# Access Compliance Report

## Public Rights-of-Way

### (Curb Ramps)

Intersection ID: 19877	Main Street: ARUNDEL_DR	Cross Street: FAIRVIEW_RD	Location: SE
ADA ID: 7614011CB09C	Ramp Type: PerpDiag	Initial Pass/Fail: Fail	Overall Compliance: No
		Severity Score: 12.5

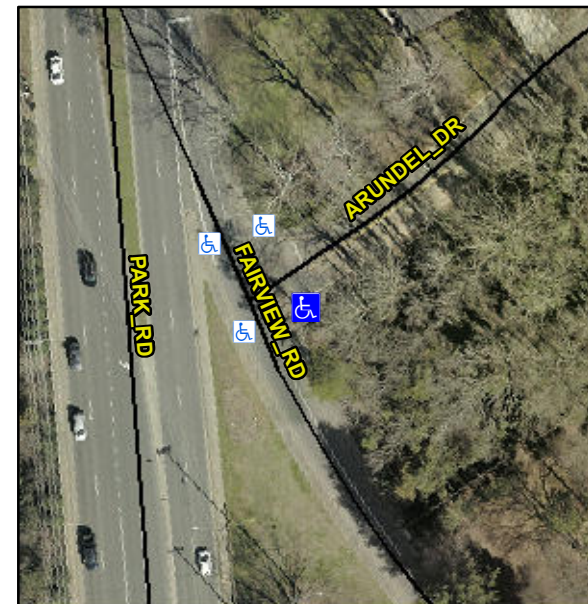
**Not Found, R304.2.2**

Compliance	Description	Data	Compliance	Description	Data
N/A	Ramp Length (in)	59.0	No	Ramp Slope (%)	10.5
Yes	Ramp Width (in)	48.0	Yes	Ramp XSlope (%)	0.1
N/A	Flare Type LT	N/A	N/A	Flare Type RT	N/A
N/A	Flare Slope LT (%)	N/A	N/A	Flare Slope RT (%)	N/A
N/A	Flare Traversable LT?	N/A	N/A	Flare Traversable RT?	N/A
N/A	Landing Length (in)	N/A	N/A	DWS Provided?	N/A
N/A	Landing Width (in)	N/A	N/A	DWS Contrast?	N/A
N/A	Landing Slope (%)	N/A	N/A	DWS Length (in)	N/A
N/A	Landing X Slope (%)	N/A	N/A	DWS Full Width?	N/A
N/A	Landing Curb? (Y/N)	N/A	N/A	DWS Offset (in)	N/A
N/A	Shared Landing?	N/A			
N/A	Gutter Ponding?	N/A	N/A	Gutter Slope (%)	N/A
N/A	Gutter Lip Ht (in)	N/A	N/A	Gutter X Slope (%)	N/A
N/A	Painted X Walk1?	No	N/A	Painted X Walk2?	No
	X Walk 1 Direction	To N		X Walk 2 Direction	To W
N/A	X Walk 1 Width (in)	N/A	N/A	X Walk 2 Width (in)	N/A
	X Walk 1 Slope (%)	0.5		X Walk 2 Slope (%)	1.4
	X Walk 1 X Slope (%)	0.3		X Walk 2 X Slope (%)	3.7

**Remove & Replace Curb Ramp With Two New Directional Ramps or Equivalent.**
